REDTAIL RANCH FILING NO. 1

CONSTRUCTION DRAWINGS

PCD No. SF-18-021

Markup Summary

RETAIL RANCH FILING NO. 1 STREET IMPROVEMENT PLAN SANCTUARY PINE DRIVE & WARD LANE			
DESIGNED BY	PRA	SCALE	DATE 06-29-18
DRAWN BY	PRA	(H) 1" = 50'	SHEET 5 OF 10
CHECKED BY		(V) 1" = 5'	JOB NO. 2525.00

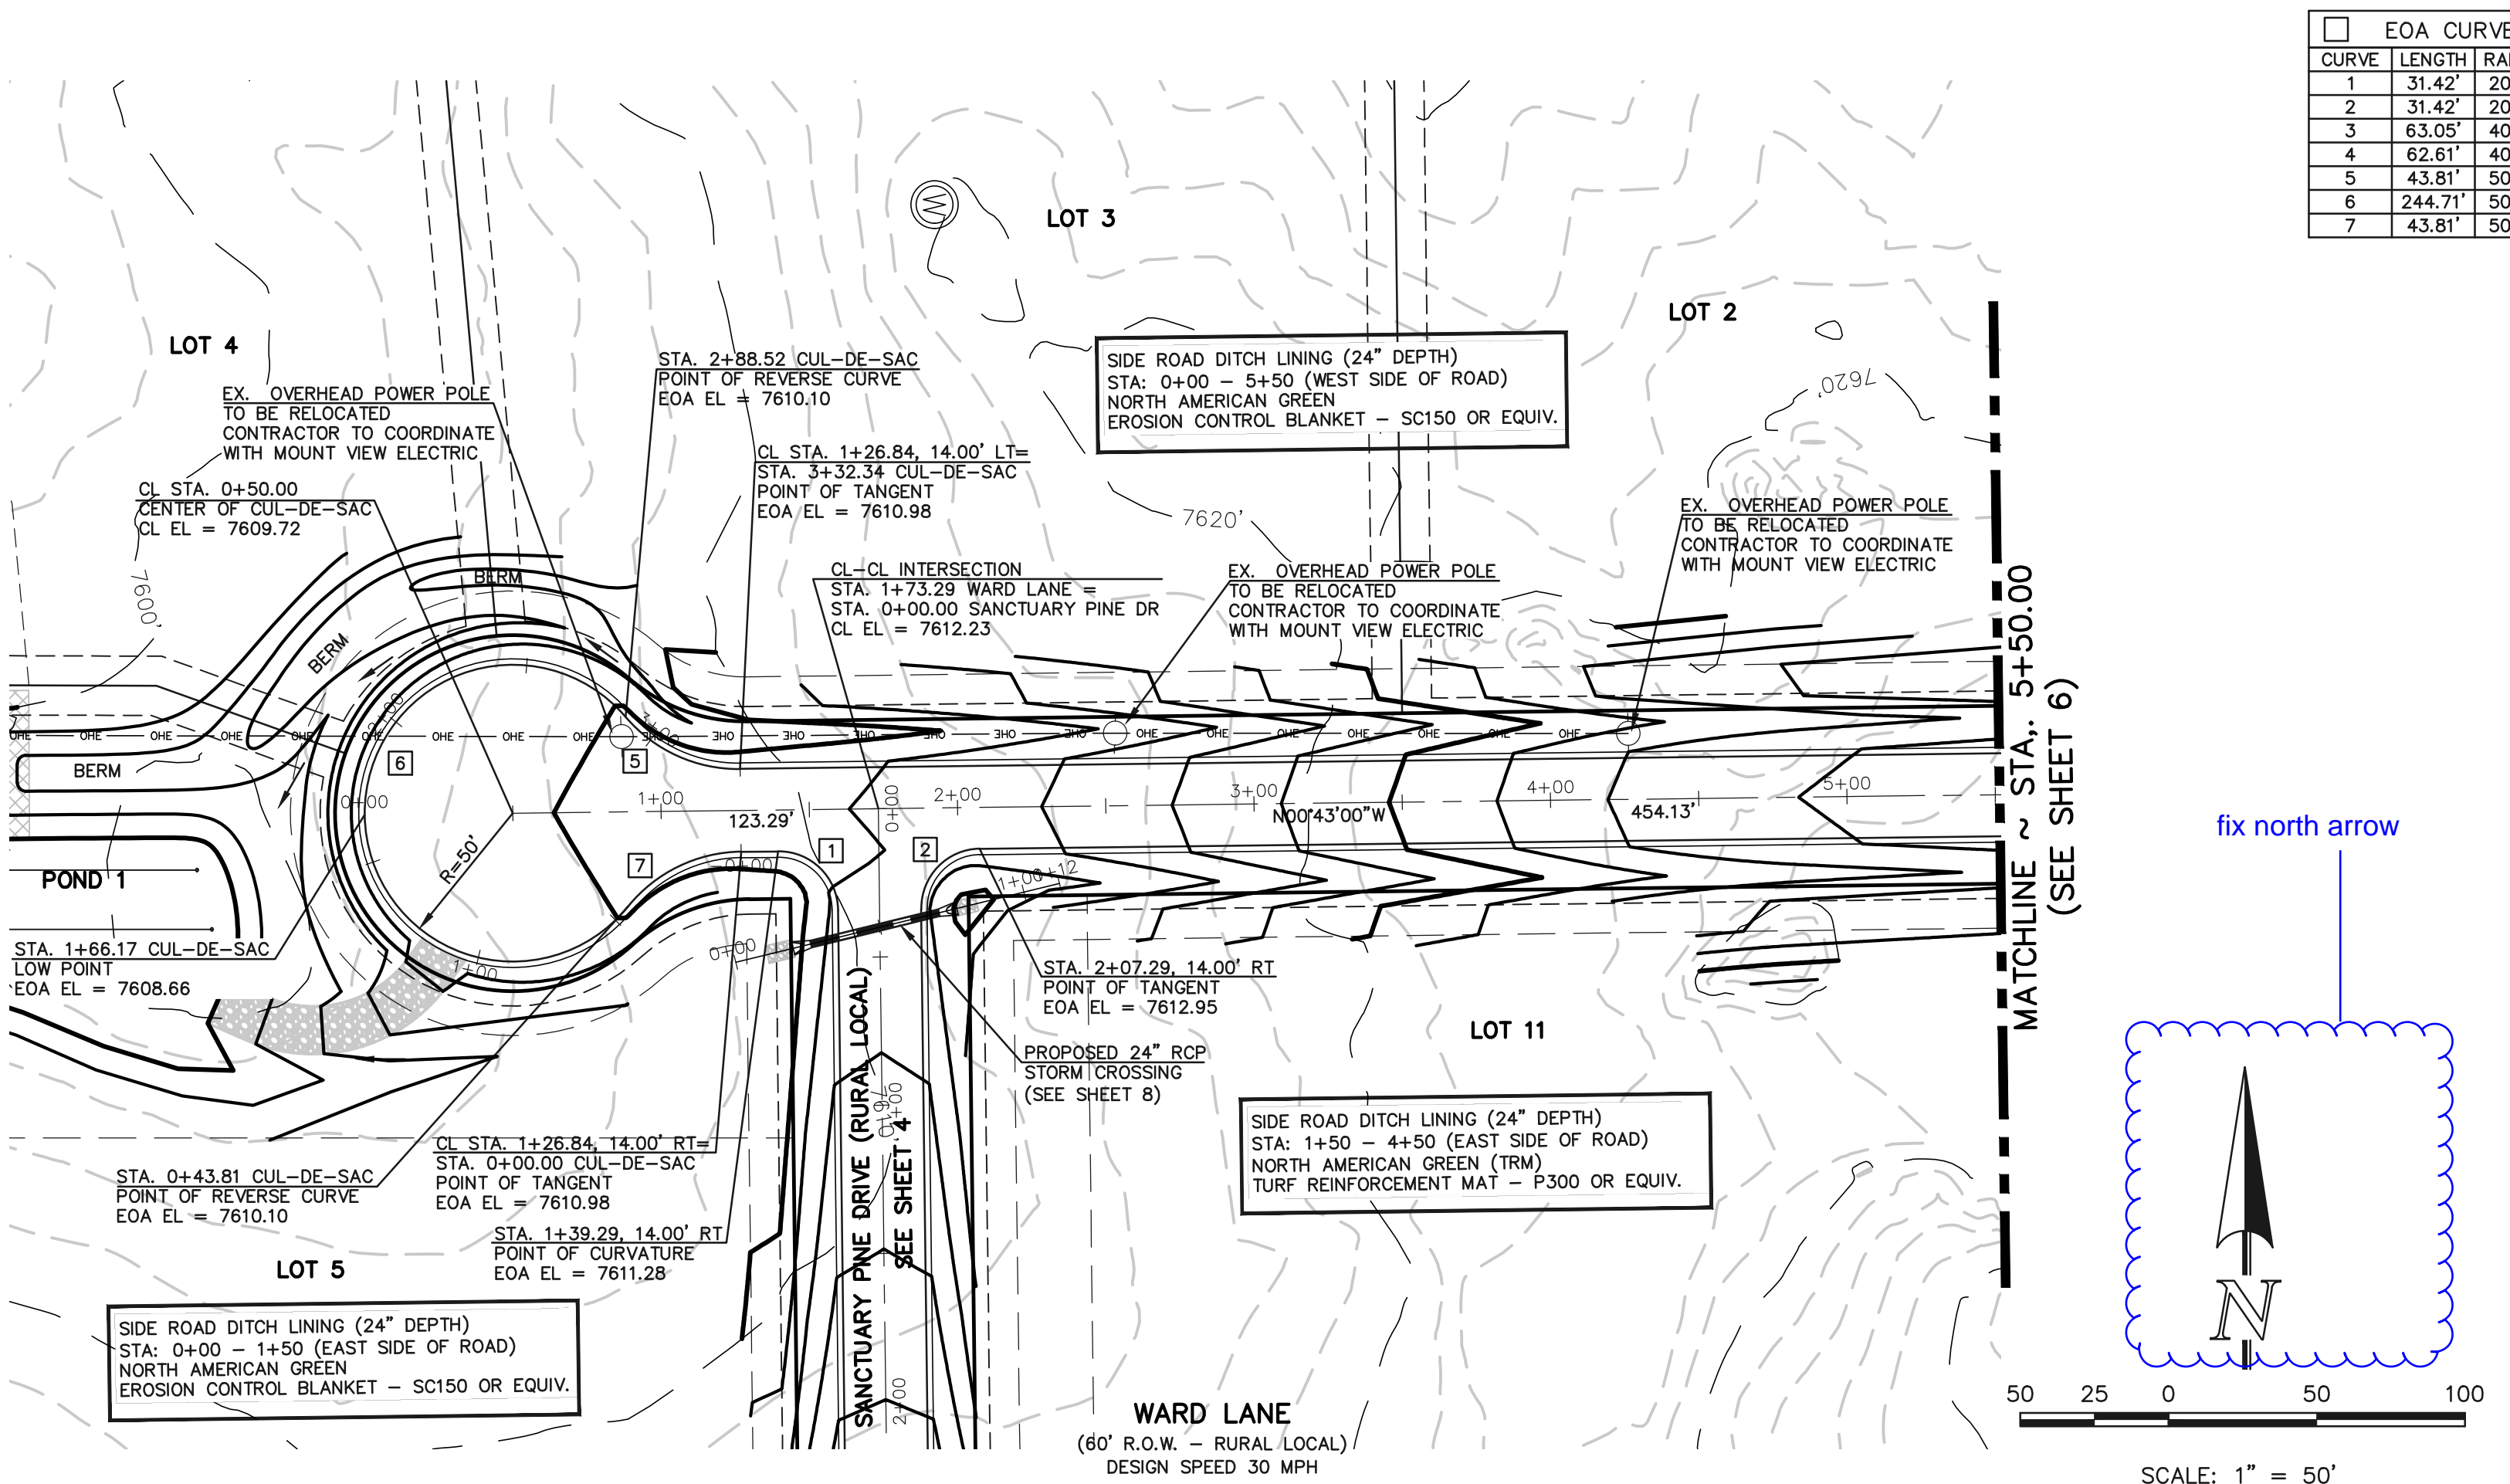
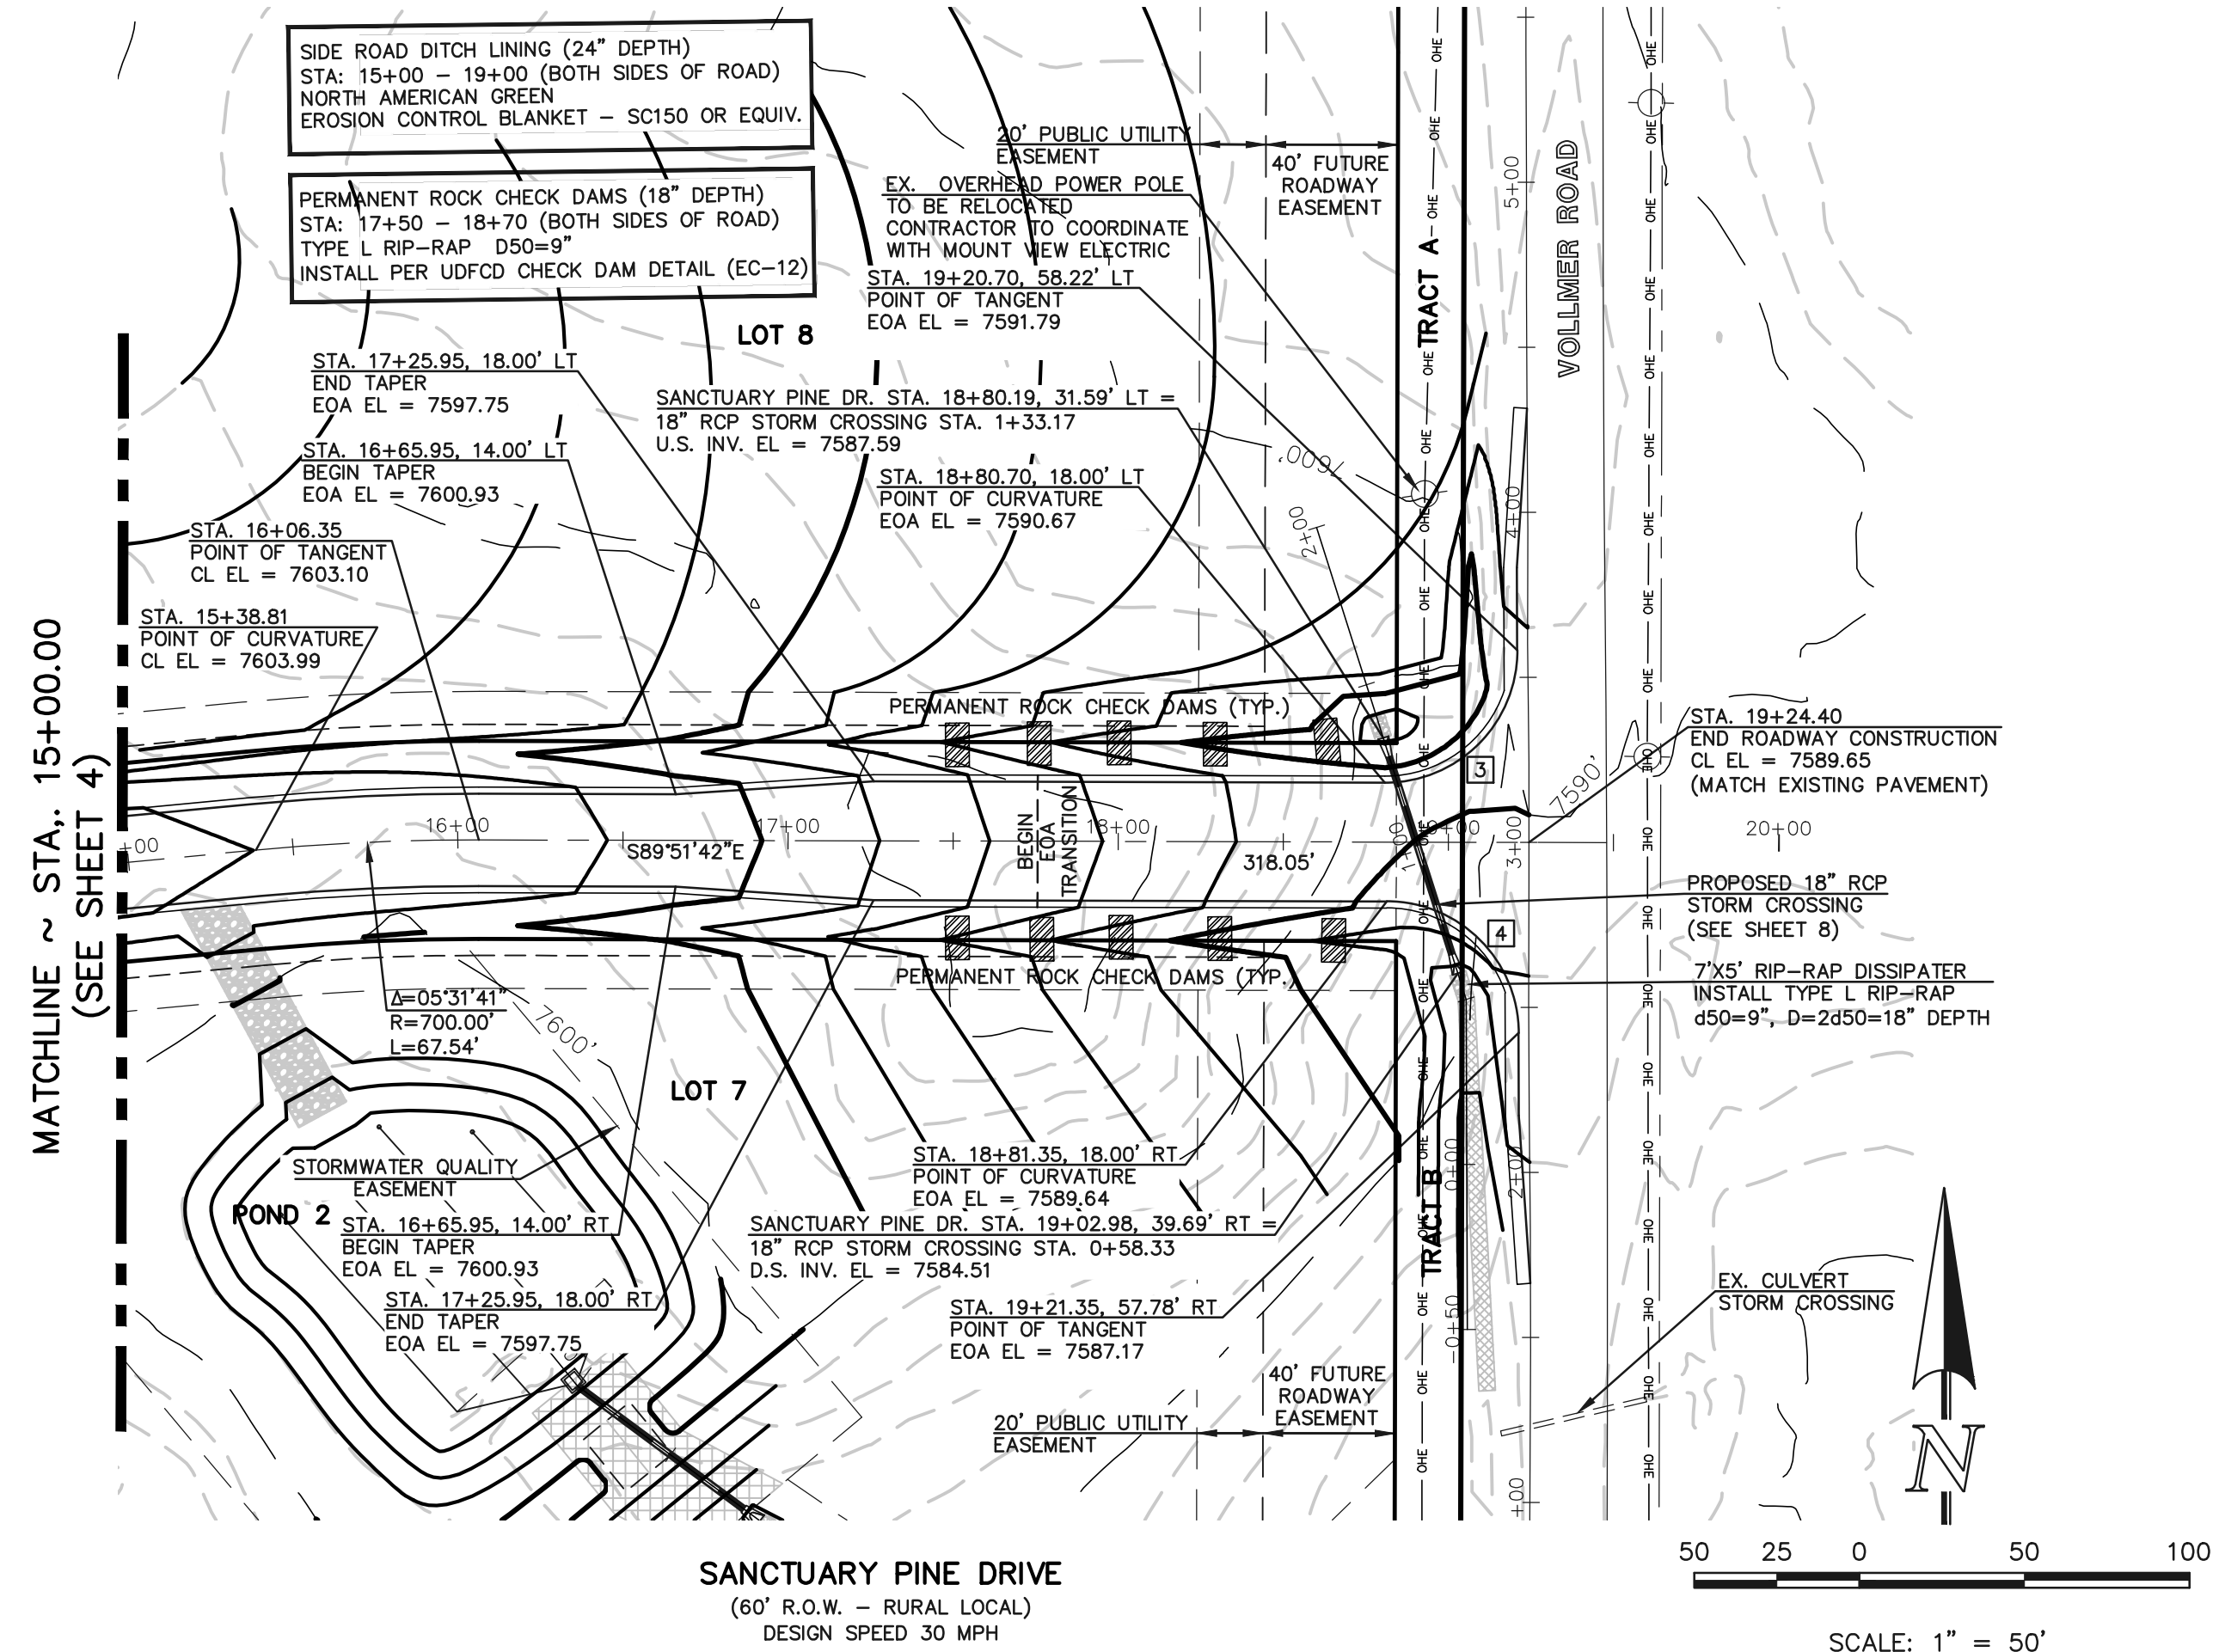
fix north arrow

REDDAIL RANCH FILING NO. 1
STREET IMPROVEMENT PLAN
WARD LANE & VOLLER ROAD

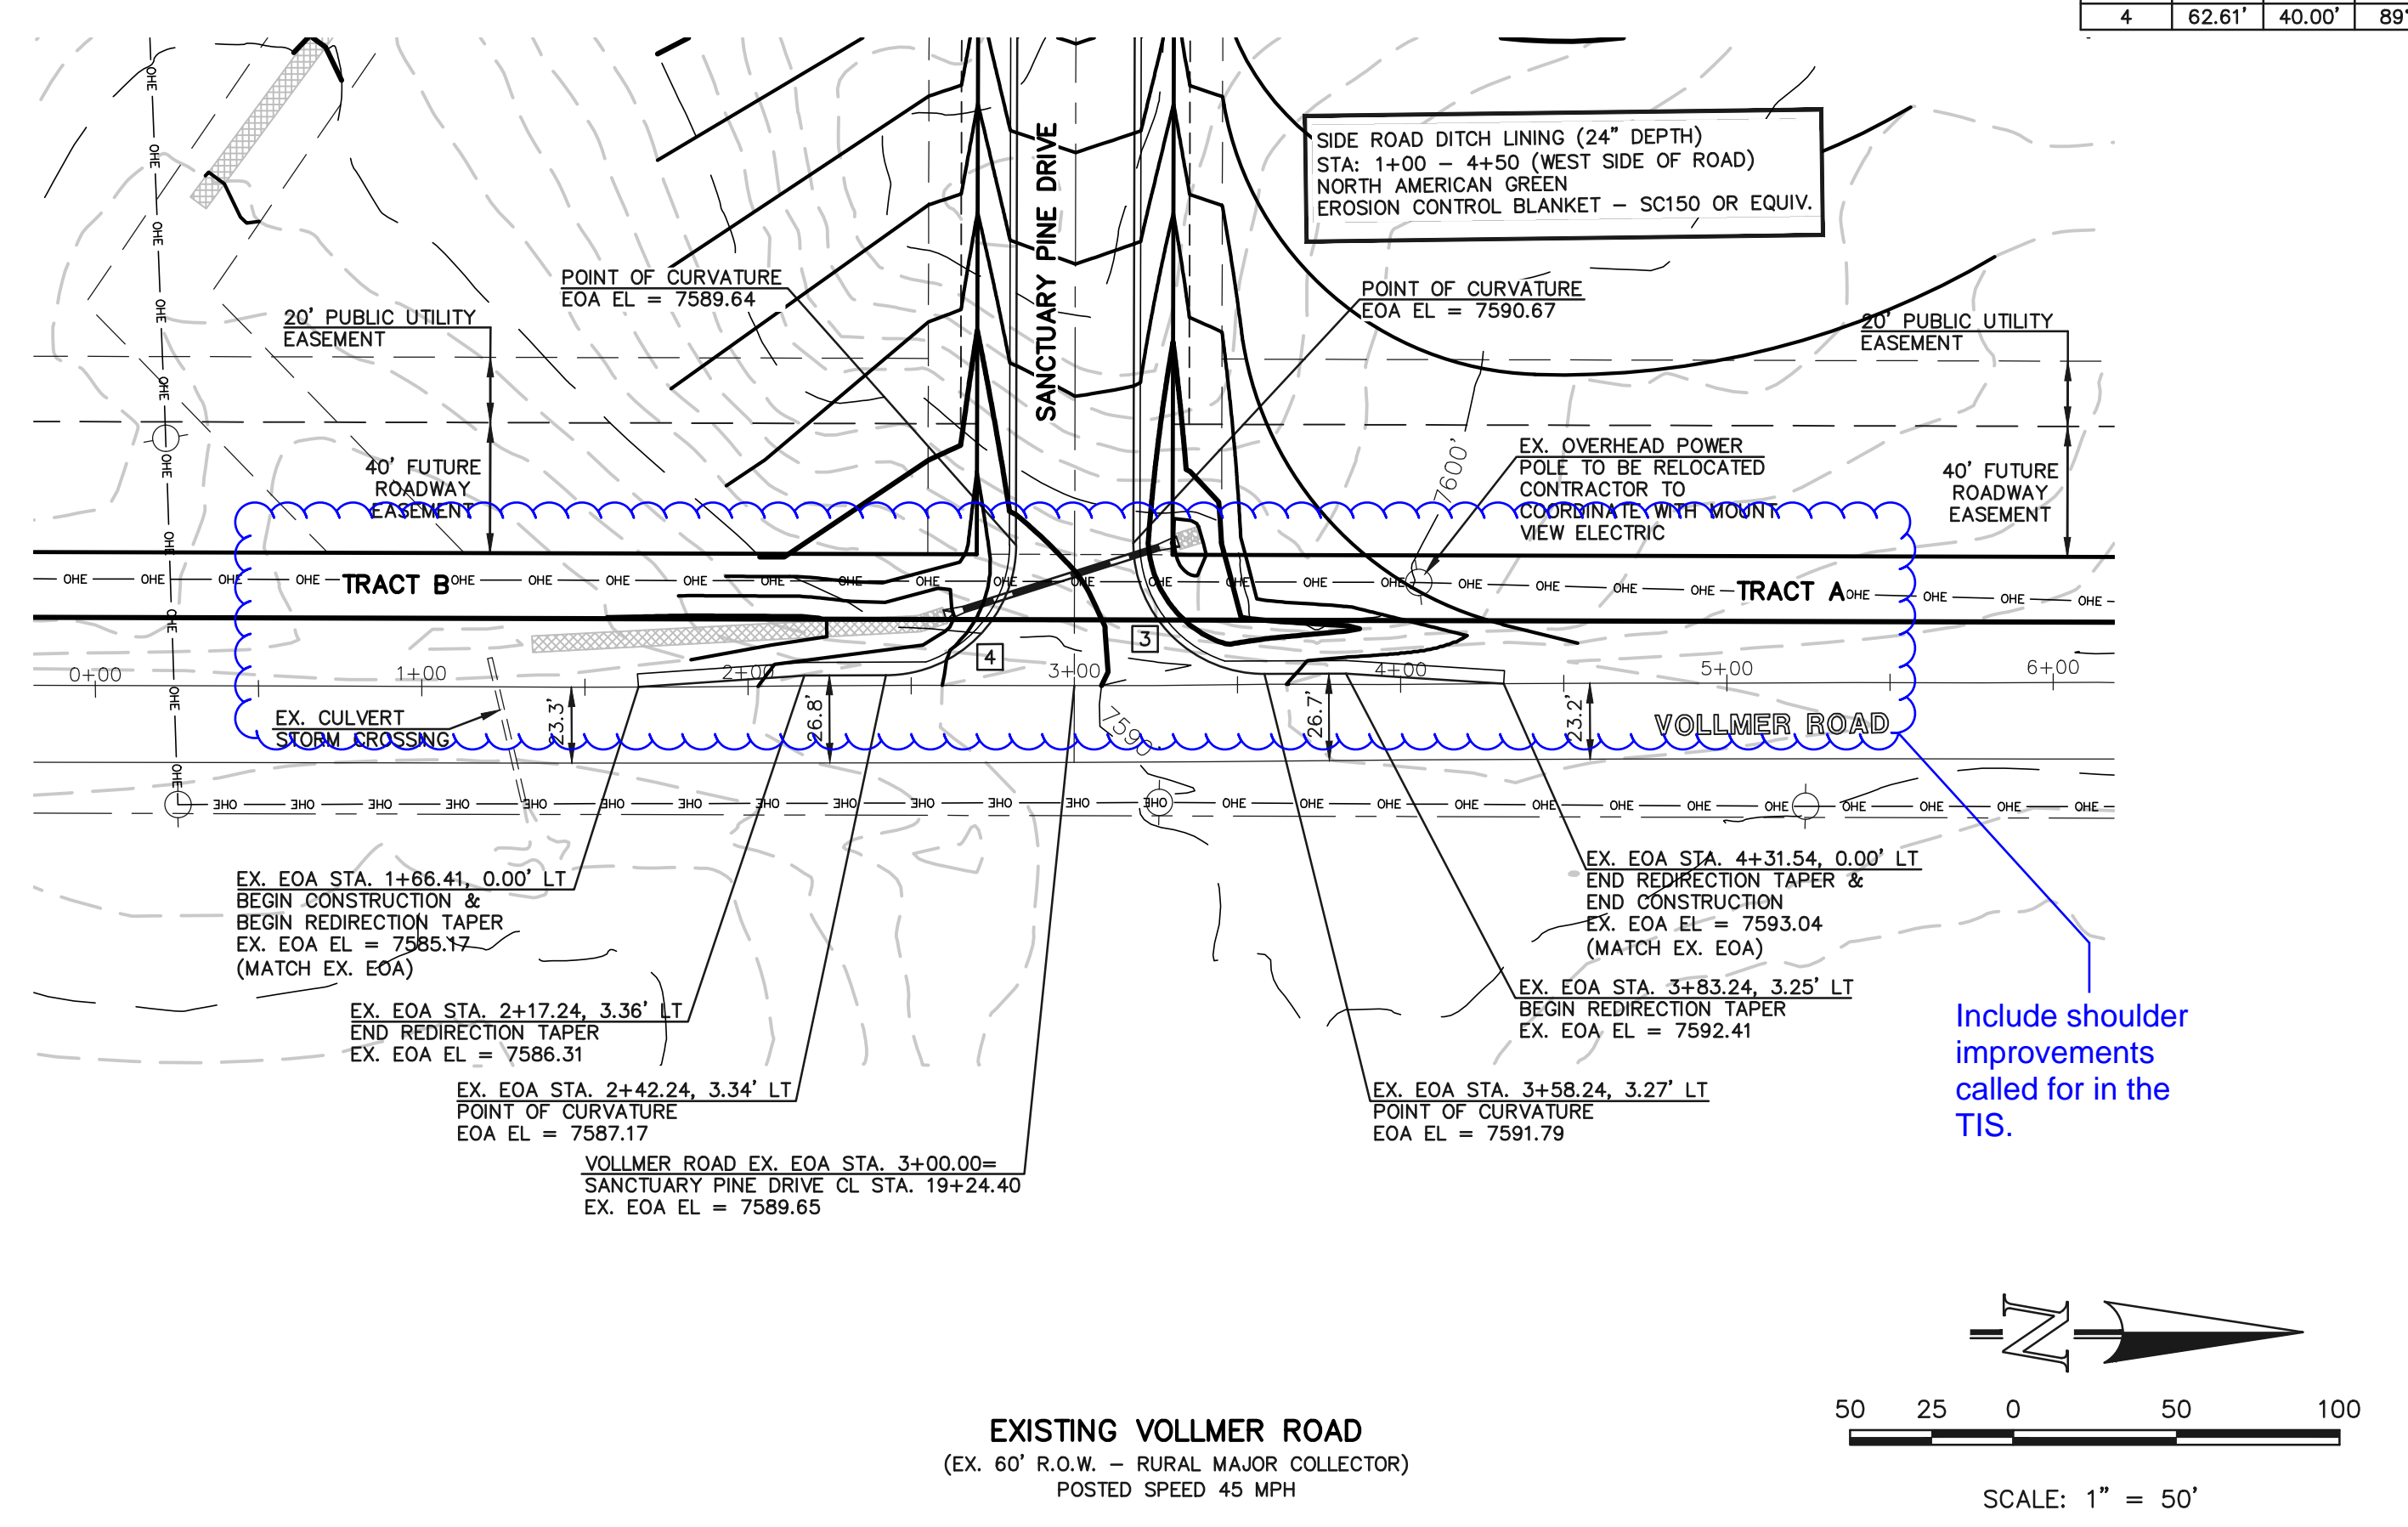
Additional details including elevations, slopes, cross-slopes etc. are necessary to show transition and to provide adequate maintenance turnaround in existing cul-de-sac ROW area. If the power pole is being relocated additional space should be available.
